SERVICE BULLETIN 89 MANDATORY

SUBJECT: FT NOSE GEAR STRUT REINFORCEMENT

APPLICATION: All Glasair I FT and Glasair II FT nose gear struts shipped before 7/13/90 or before kit number 2083.

FIGURE (1)

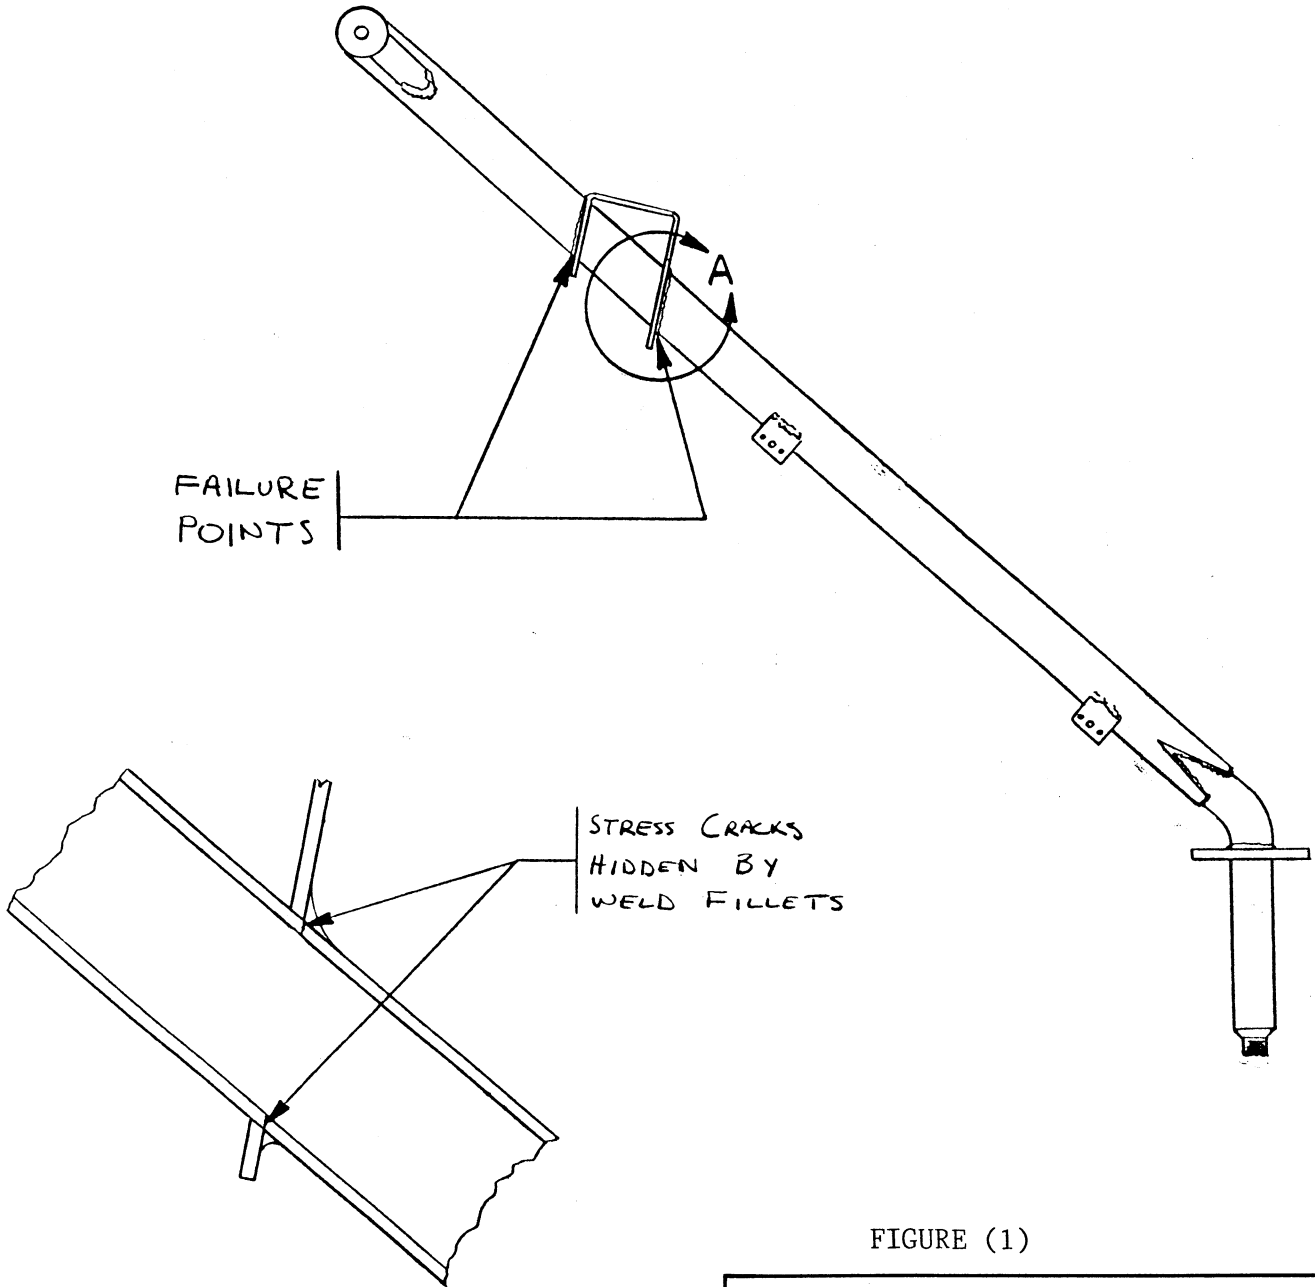
DESCRIPTION: After two failures of FT nose gear struts in the field, we are requiring that the struts be reinforced to prevent further failures that may cause serious damage or injury. Nose gear struts may fail at either the upper or the lower weld around the 1-3/8" diameter tube at the shock truss assembly, as shown in FIGURE (1).

The exact cause of the failures is unknown, but they have occurred at highly stressed parts of the strut. In both instances, a stress crack began under the weld between the shock strut channel and the strut tube in a location that cannot be inspected until after a failure has occurred. Refer to the Detail in FIGURE (1).

FIGURE (2)

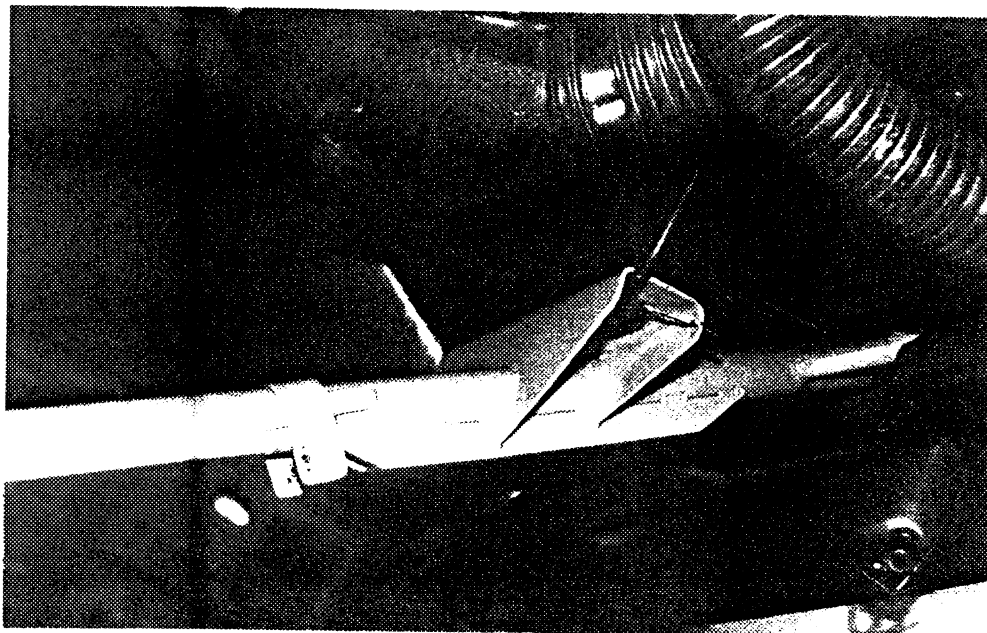
If you wish to have Stoddard-Hamilton Aircraft rework your nose gear strut, return it to us by 11/30/90. We will modify the strut by welding a 4130 steel channel reinforcement to the underside, as shown in FIGURE (2). Since the welding process alters the original heat treatment, we will have the strut reheat-treated to the original specification. After heat treatment, the strut will be cadmium plated and powder coated. As with all of our engine mounts and landing gear struts, we now specify a light gray powder coating (rather than black) to make any possible future cracks more visible. The cost for reworking your strut is \$119.00 plus shipping. The first 100 struts received by Stoddard-Hamilton will be returned to the builders by 1/31/91. A second production run for strut rework will be scheduled later, with a return date to be announced.

Alternatively, you may wish to have the strut reworked locally. The 4130 steel reinforcement channel (trimmed, slotted, and ready for installation) may be purchased from Stoddard-Hamilton Aircraft for \$10.50, plus shipping. Your total cost for the rework may be higher locally because of minimum lot charges, but the work could be done on your own schedule.

To reinforce the nose gear strut, first have it stripped of paint and cadmium plating. Before welding, preheat the strut in the areas of the welds to 400° F. Weld using the TIG (tungsten inert gas) welding process. After welding, let the strut cool slowly in air or in sand, and then have it heat-treated in a local shop to 140-150 Ksi. Finally, have the strut cadmium plated for corrosion protection, and then powder coated or painted.

CAUTION: Cadmium plated steel parts must be baked by the electroplating shop after plating to drive out any hydrogen that might have been introduced into the steel by the electroplating process. Such hydrogen, if not removed, can lead to cracking in the steel; this is known as hydrogen embrittlement. Also, when ordering the cadmium plating, stipulate that it must meet the QQ-P-416E Type II Class 3 specification.
